**SUBMITTAL TO THE BOARD OF SUPERVISORS  
COUNTY OF RIVERSIDE, STATE OF CALIFORNIA**

**SUBJECT:** DEPARTMENT OF WASTE RESOURCES: Contract Change Order No.1 for the Construction of Daily Cover Excavation and On-Call Site Improvements at Badlands and Lamb Canyon Sanitary Landfills, District 5 [\$921,740 –Department of Waste Resources Enterprise Funds] (Nothing Further Required under CEQA)

**CONTRACT CHANGE ORDER NO. 1**

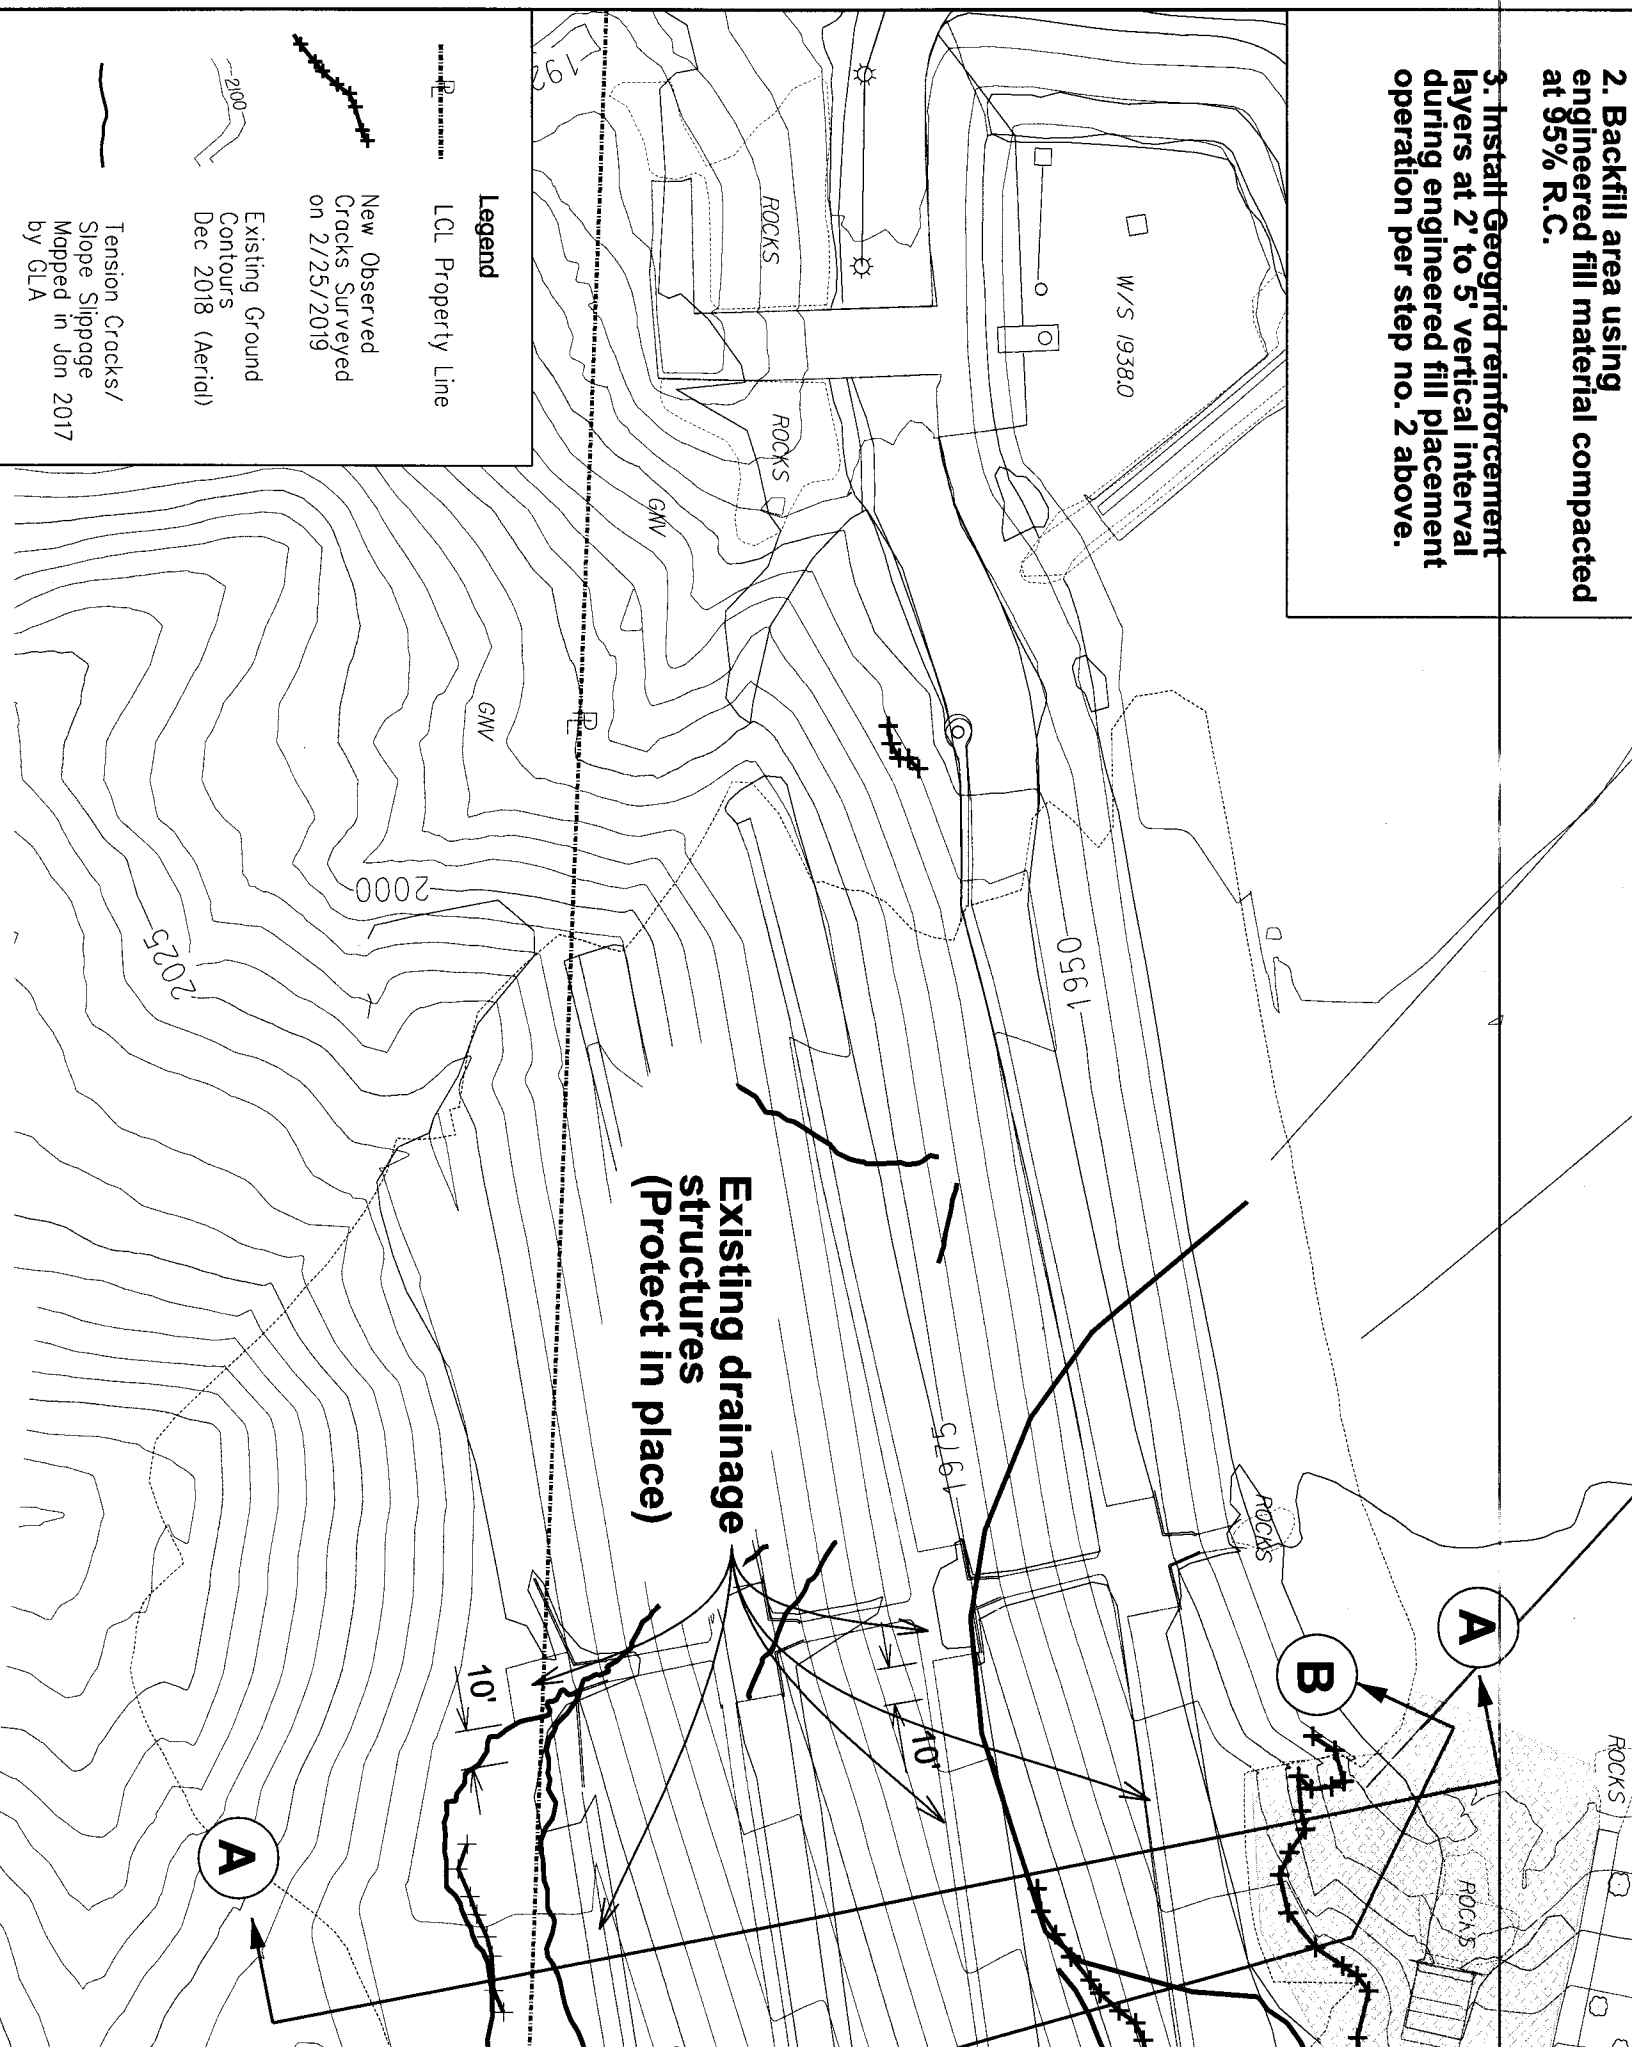
**Work Item No. 7**  
Recover and regrade wet weather pad

**Work Item No. 6**  
Finish material removed from access road with material from south soil stockpile

**Work Item No. 3**  
Repair eroded landfill side slopes

**Section B-B**

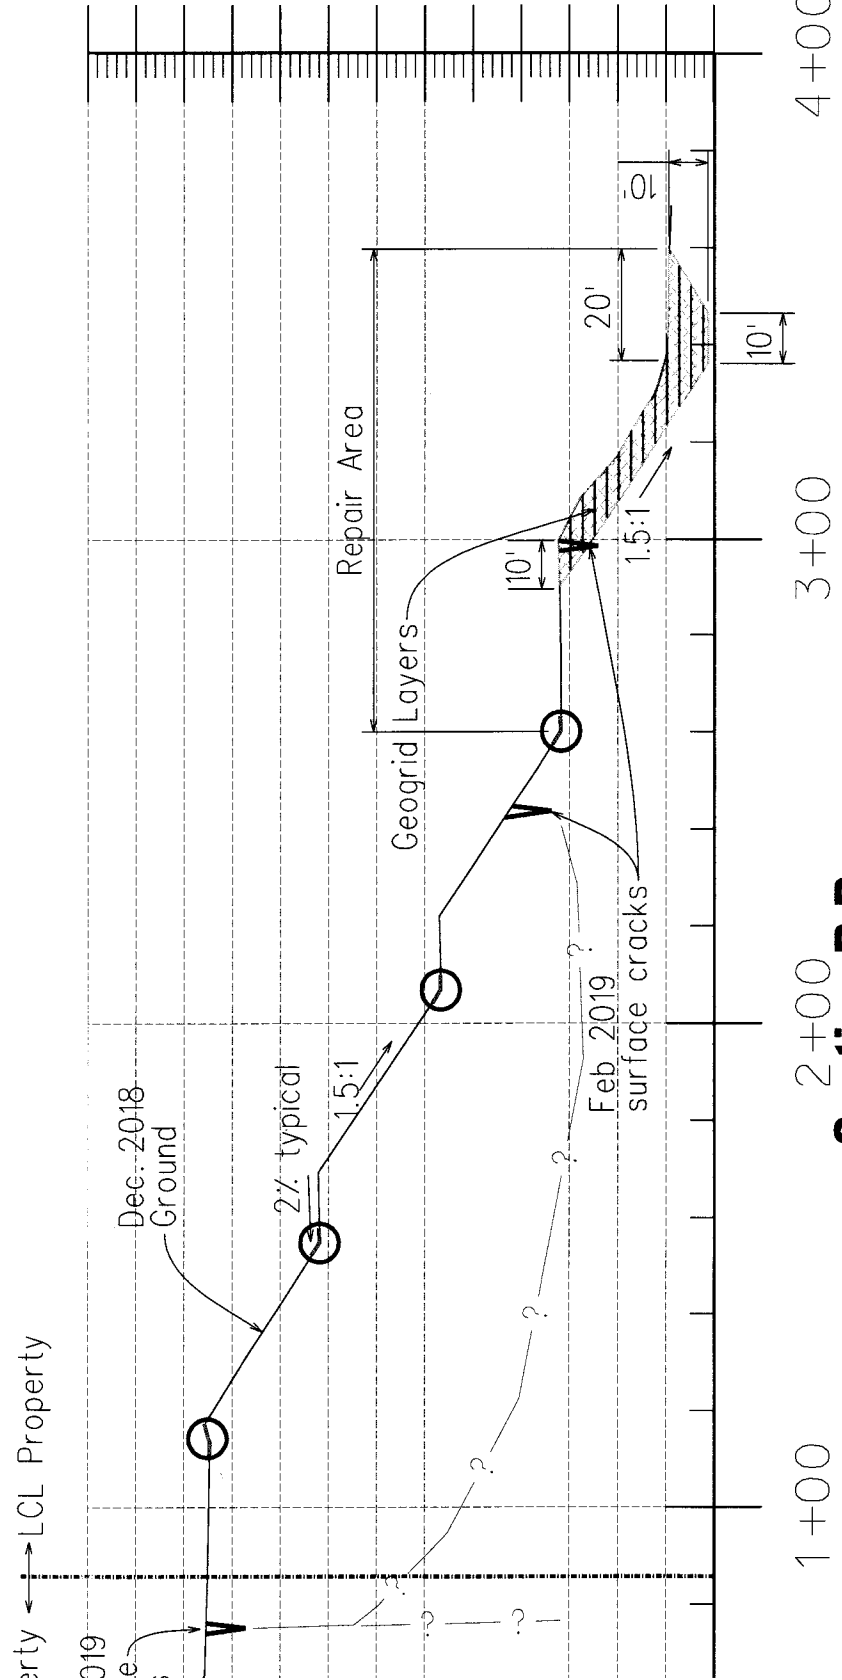
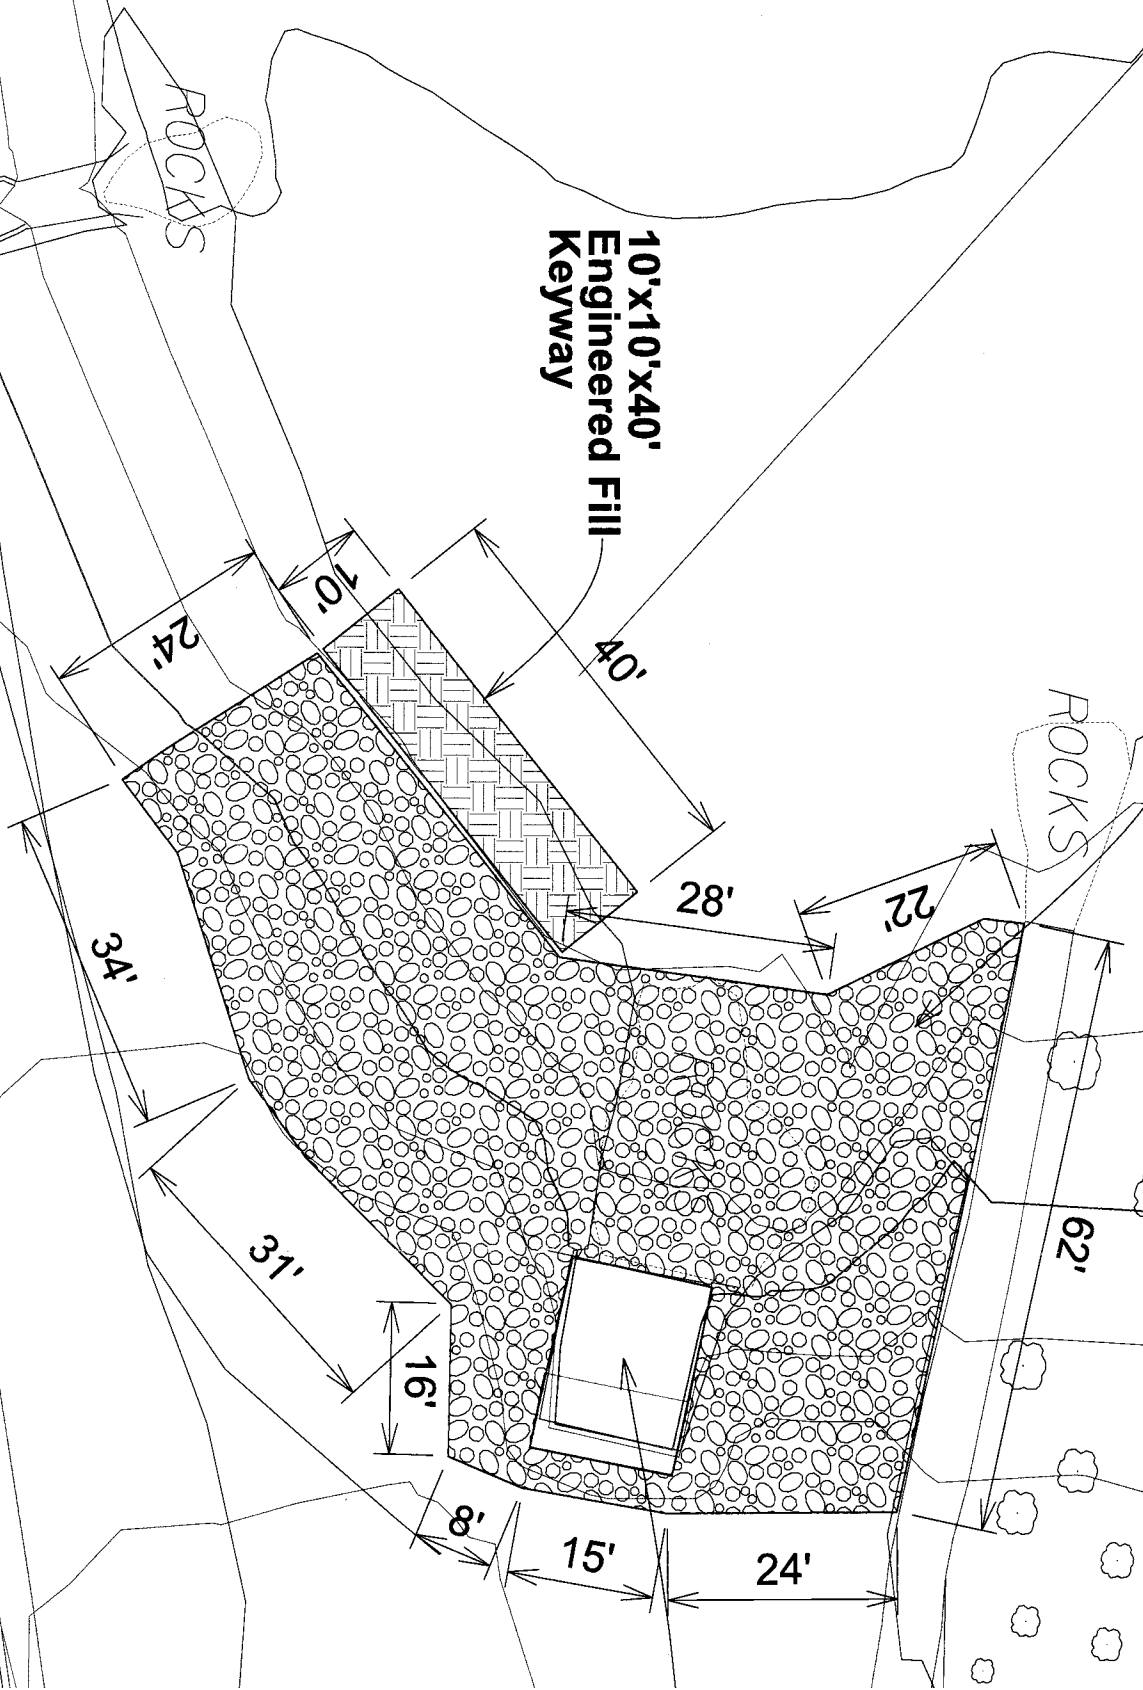
10'x10'x40'  
Engineered Fill  
Keyway
